Gate Burton Energy Park Environmental Statement

Volume 3, Appendix 10-K: Lincolnshire County Council Consultation Meeting Notes
Document Reference: EN010131/APP/3.3
January 2023

Minutes

Meeting name	Subject	Attendees
Gate Burton Solar Farm	Review of additional viewpoints/photomontages suggested by Lincolnshire County Council	OB - Oliver Brown (on behalf of LCC) JS - Joerg Schulze (AECOM) RW - Rupert Wilson (AECOM)
Meeting date	Time	
30.03.2022	2.30pm	
Location	Prepared by	
MS TEAMS	Rupert Wilson, Joerg Schulze

Summary of individual viewpoint review (Letters correspond to enclosed viewpoint map):

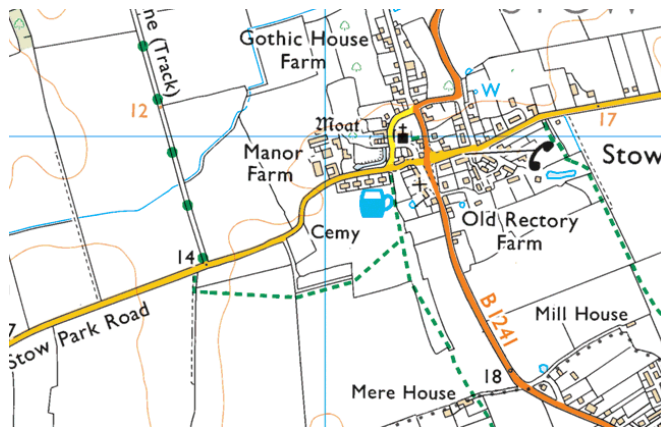
- A (Knaith Hill): OB confirms requirement of additional photomontage from edge of settlement to indicate View / No-View.
- B (Knai/44/1): OB confirms photomontage from this viewpoint to illustrate impact on PRoW users.

- B (Knai/44/2): OB states sensitivity of view. Viewpoint photography is sufficient. No photomontage required.
- B (Upto/53/1): OB confirms photomontage requirement from this viewpoint due to openness of view.

- C: OB confirms photomontage requirement and states view from C has higher importance than view from D.
- D: OB confirms that viewpoint photography is sufficient. No photomontage required.

- E: OB confirms that viewpoint photography is sufficient. No photomontage required. JS also mentioned taking a photo to the east, southeast towards Stow to review potential cumulative effects with the proposed West Burton Solar Farm.

- F1: Scoped out – OB confirms that viewpoint photography is sufficient. No photomontage required.
- F2: Scoped out – OB confirms that viewpoint photography is sufficient. No photomontage required.

- F3: JS said that this location is similar to VP20. OB suggested that the location of F3 offers slightly more views than VP20. OB suggested this should be a photomontage. OB suggested that once verified site photography has been done from this location, view to be reviewed with OB and see if photomontage is required or not.
- F4: OB mentioned that there are a number of PRoW's in the area (please see OS mapping extract below) – OS is concerned over long distance views to the site. OB suggested that once verified site photography has been done from this location, views to be reviewed with OB and see if photomontage is required or not.

- G: OB suggested that once verified site photography has been done from this location, view to be reviewed with OB and see if photomontage is required or not.
- H: OB suggested that views are unlikely from this location but that some taller elements of the proposed development may become discernible. OB suggested wireframe photomontage.
- I: View to be included as orientated towards eastern edge of the site from B-road. OB suggested that once verified site photography has been done from this location, view to be reviewed with OB and see if photomontage is required or not. JS mentioned potential long distance view towards the substation.

Viewpoint 1: PRow Footpath Stow/71/2

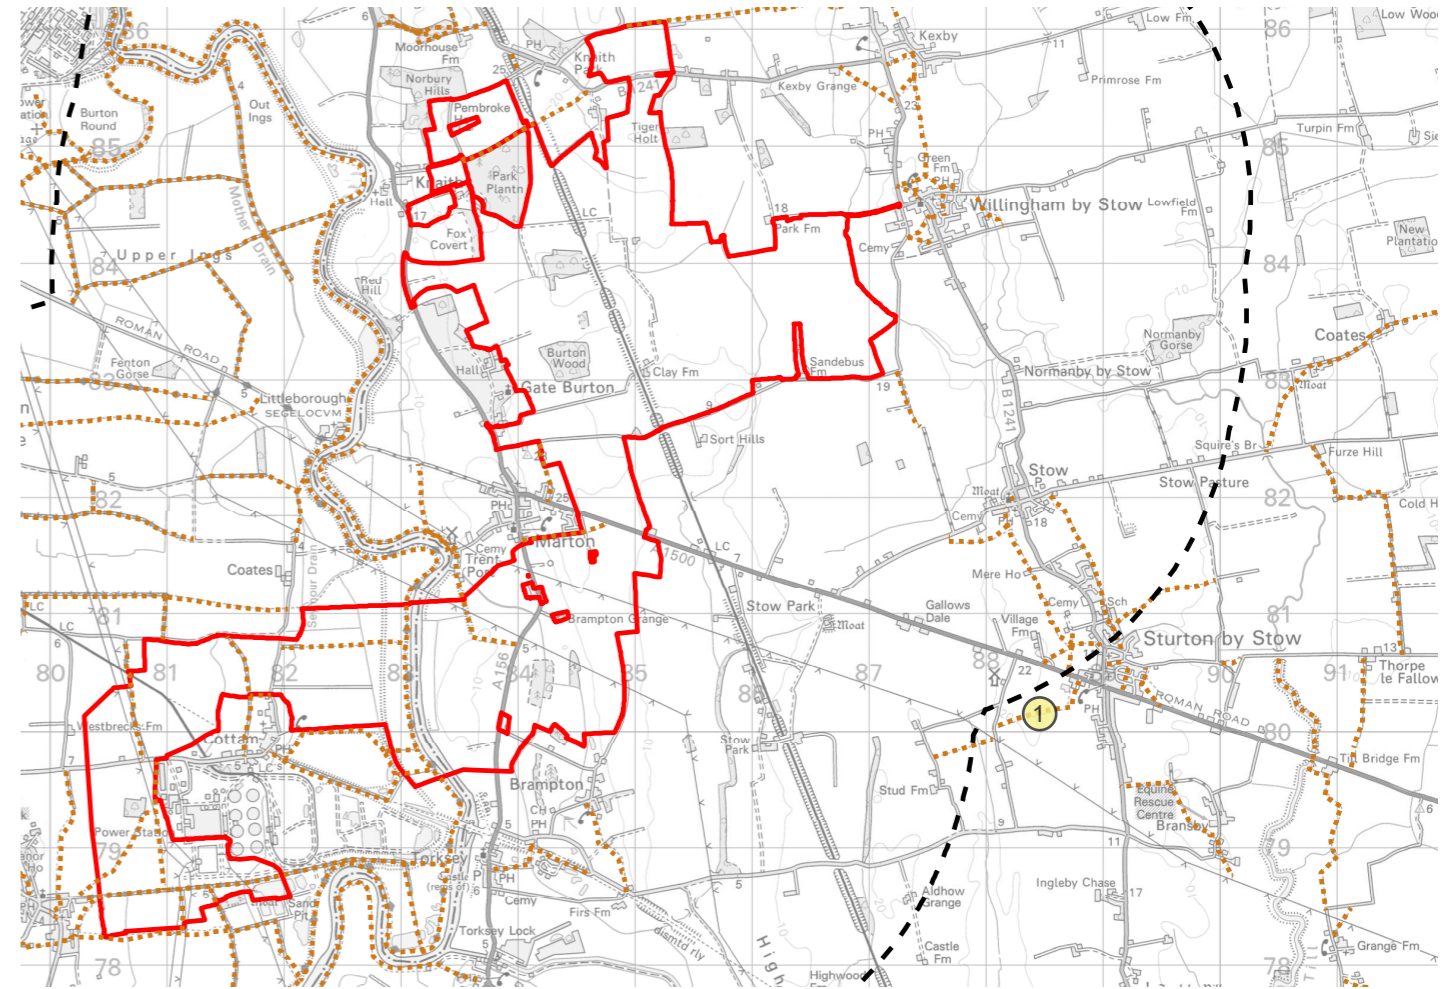
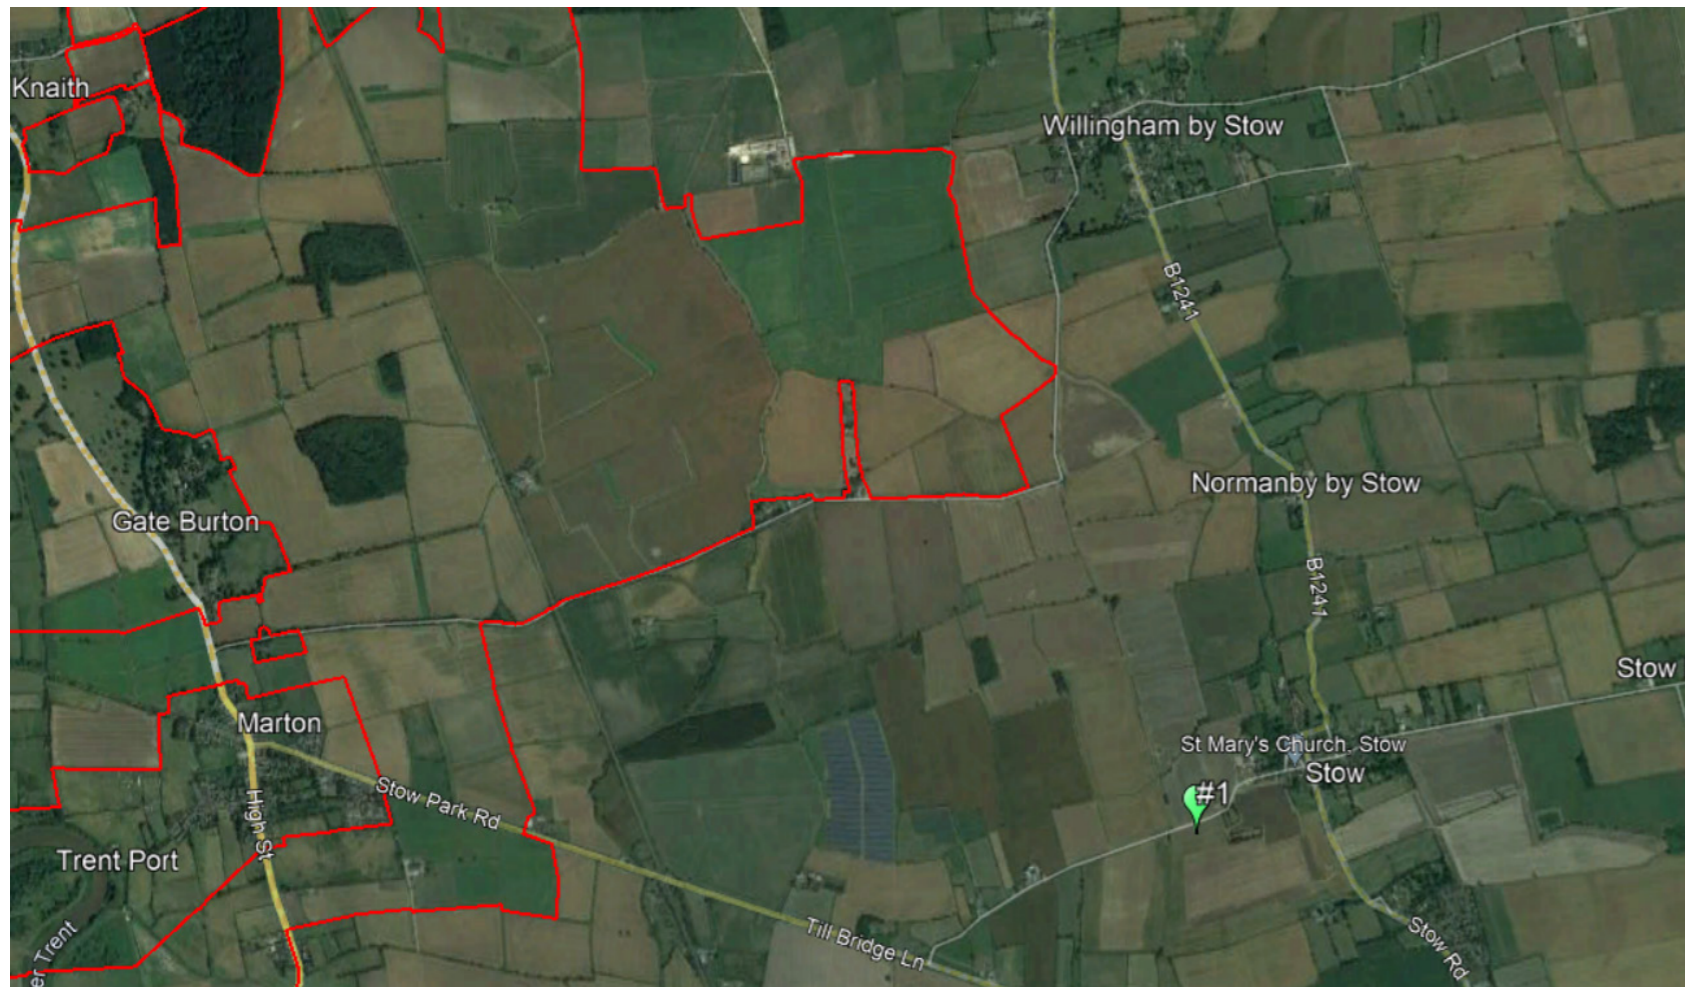
Viewpoint 1 will not have a view of the Solar Park - No Photomontage Suggested.

- Viewpoint 1: PRoW Footpath Stow/71/2 - Viewpoint 1 will not have a view of the Solar Park - No Photomontage Suggested. **AGREED**
- Viewpoint 2: PRoW Restricted Bridleway; Stow/70/1 - Viewpoint 2 may have a glimpse of the upper parts of the solar panels from this viewpoint, however, this is the only gap in vegetation along this PRoW. Photomontage Suggested. **AGREED**

Viewpoint 2: PRow Restricted Bridleway; Stow/70/1

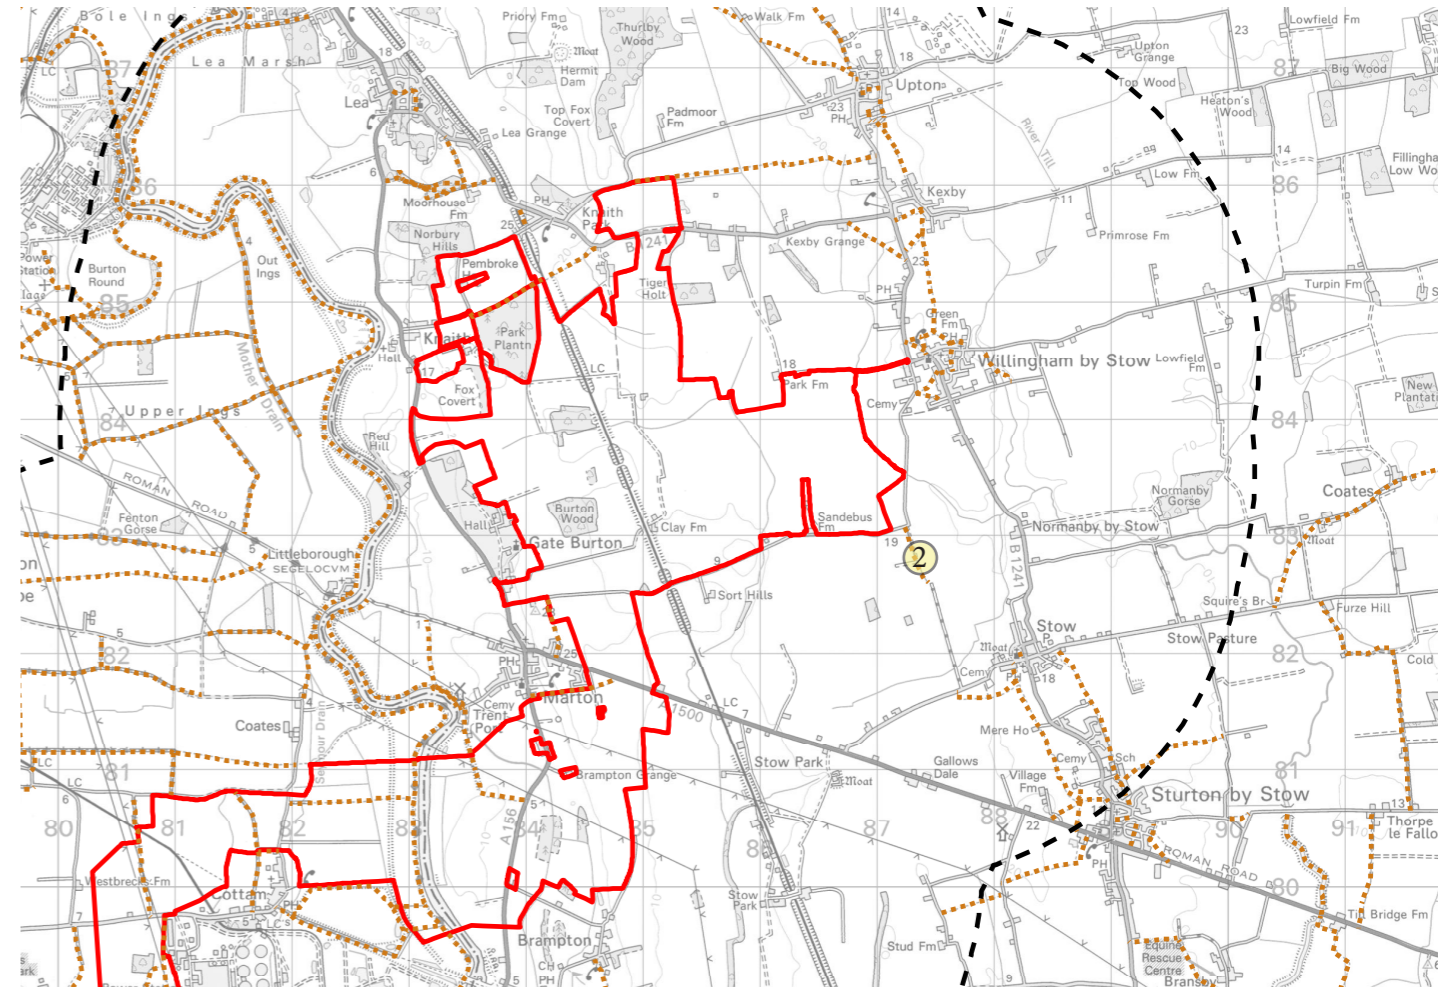
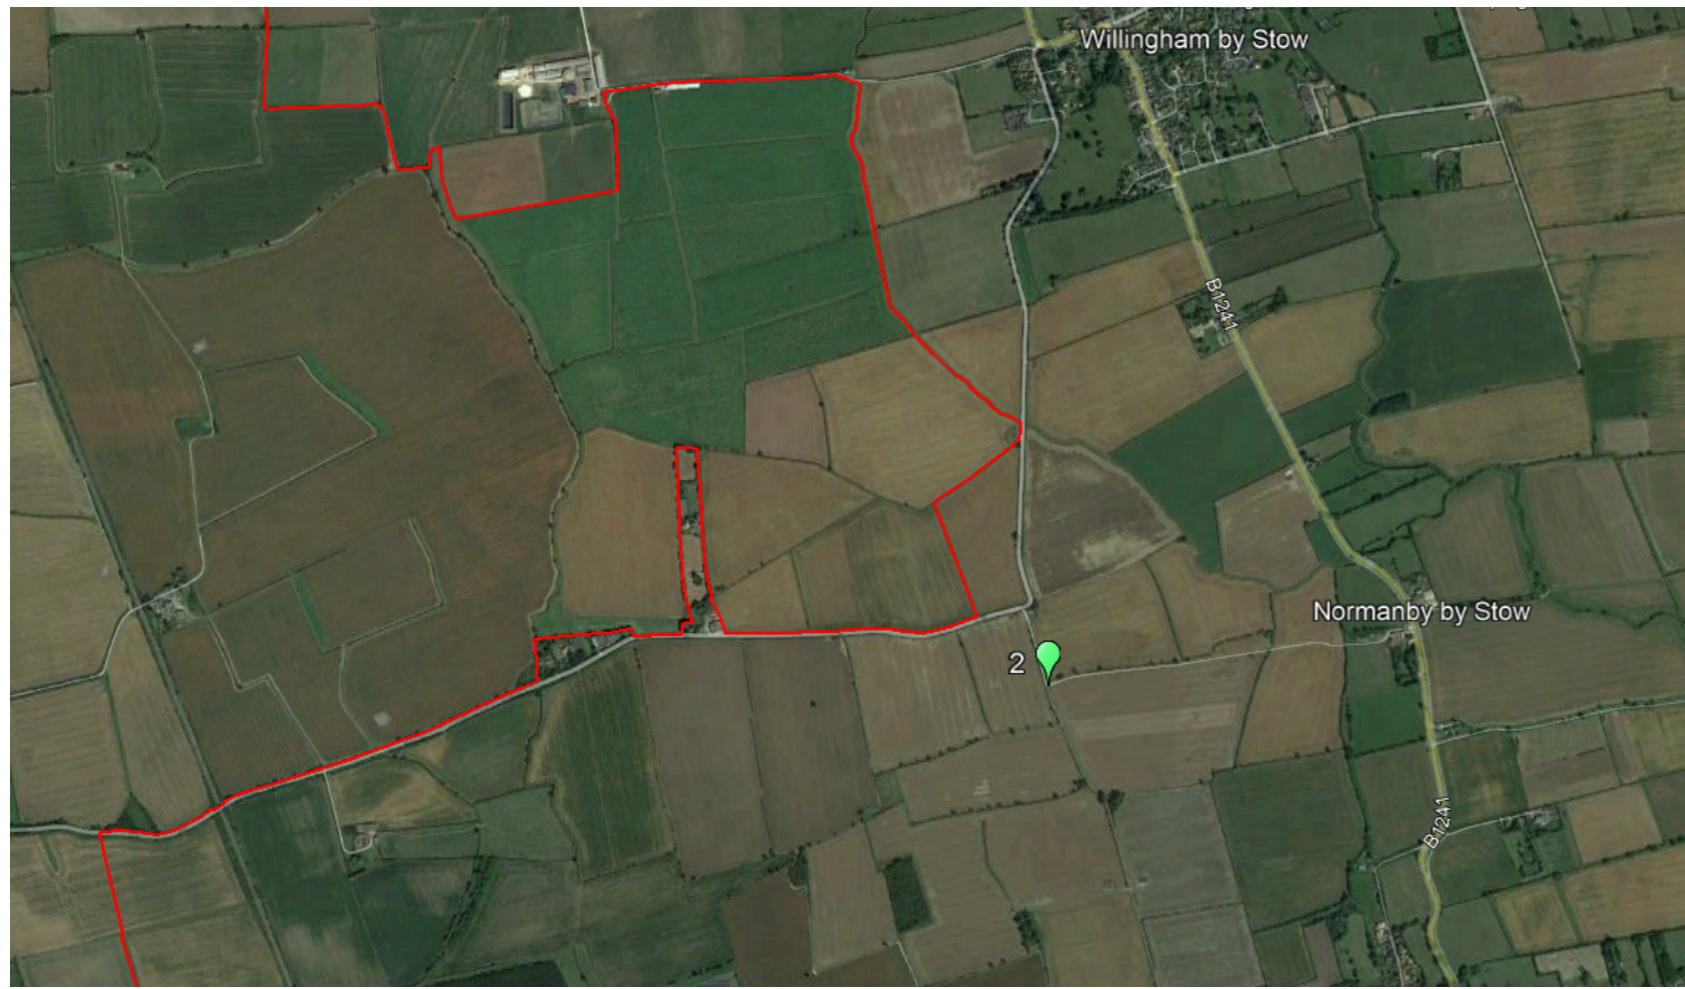
Viewpoint 2 may have a glimpse of the upper parts of the solar panels from this viewpoint, however, this is the only gap in vegetation along this PRow. **Photomontage Suggested.**

Viewpoint 3: PRoW Public Footpath; Kexb/58/1

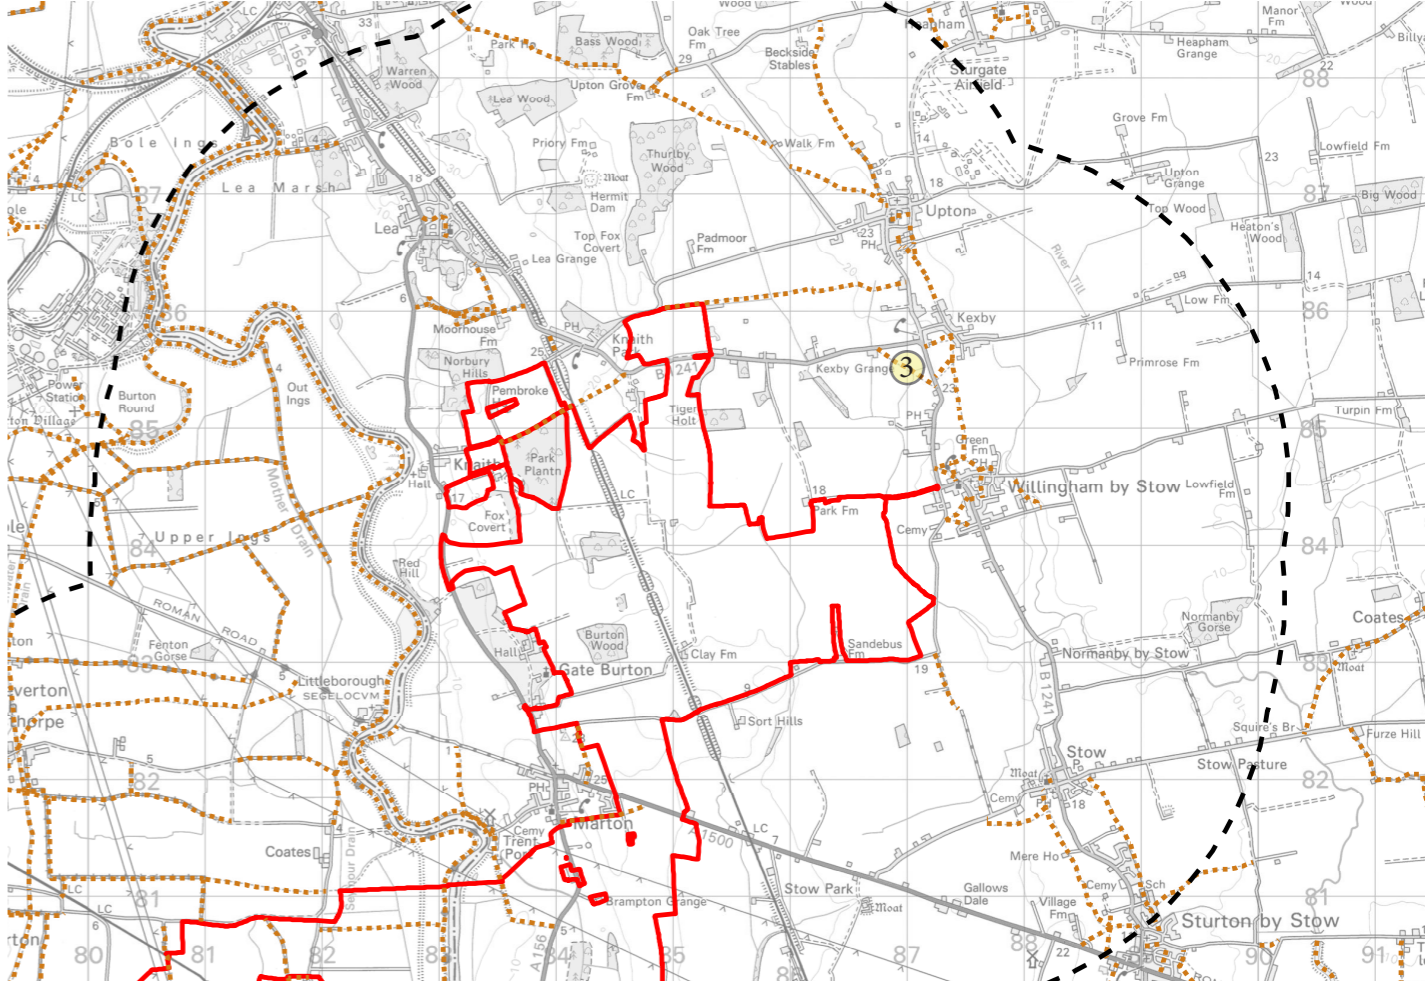
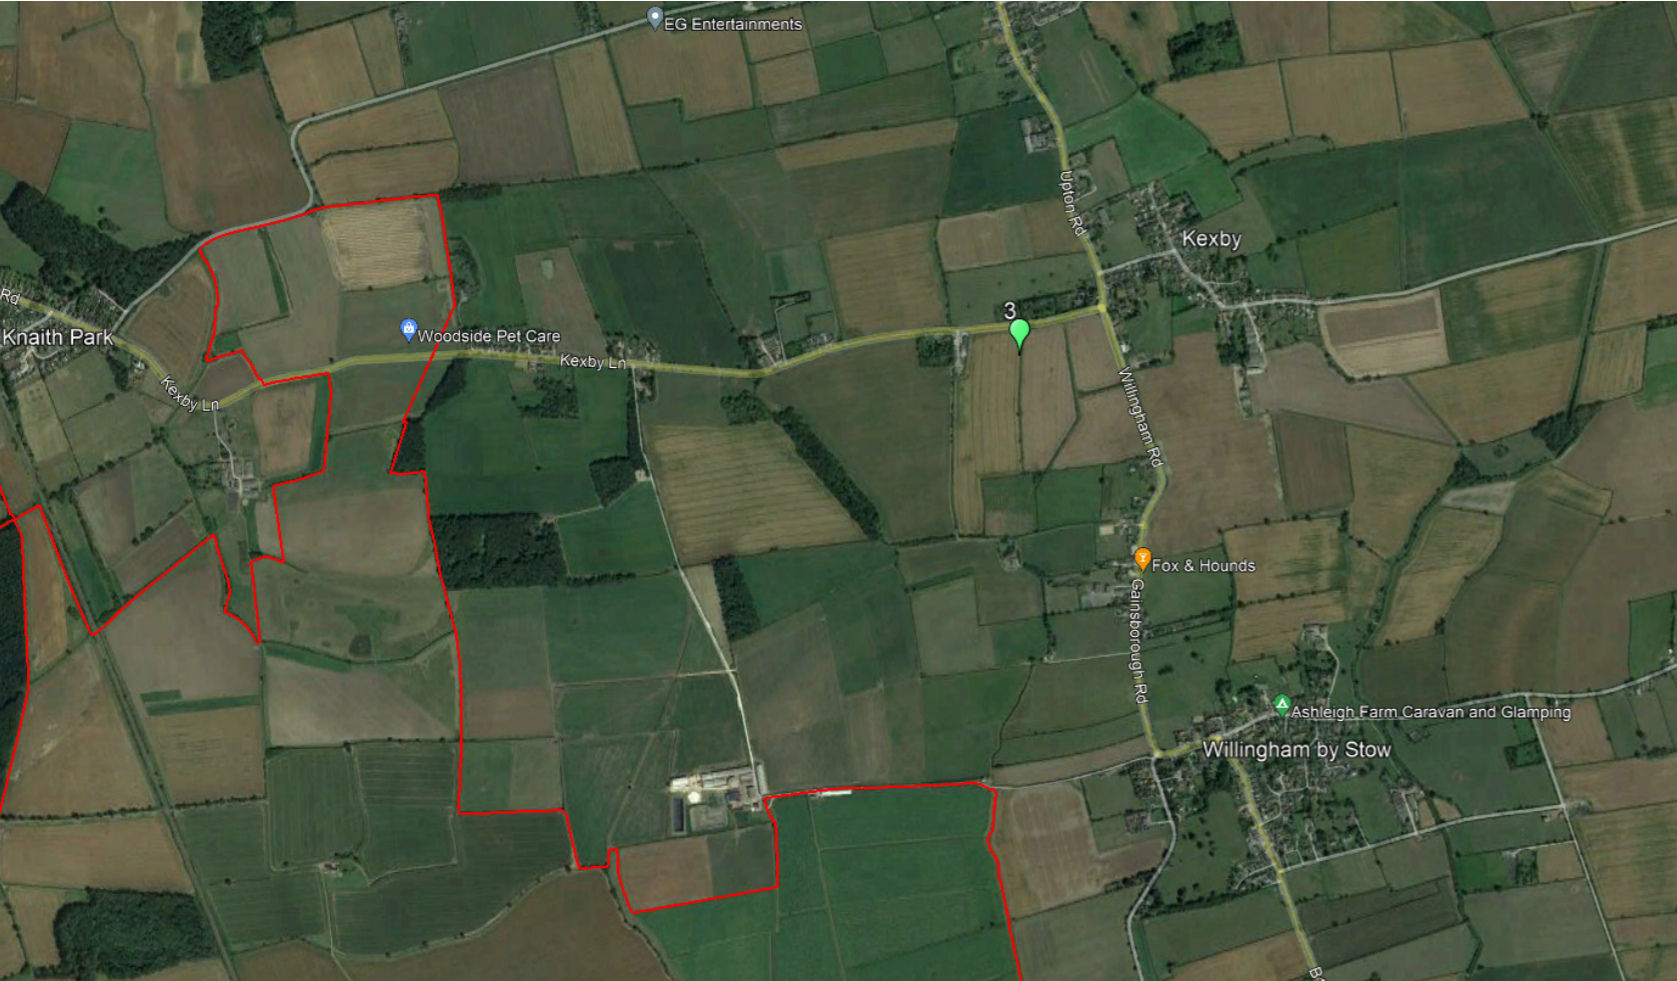
Viewpoint 3 will not have a view of the solar park due to screening provided by the field boundaries seen in this image. **No Photomontage Suggested.**

- Viewpoint 3: PRoW Public Footpath; Kexb/58/1 - Viewpoint 3 will not have a view of the solar park due to screening provided by the field boundaries seen in this image. No Photomontage is Suggested. **AGREED**
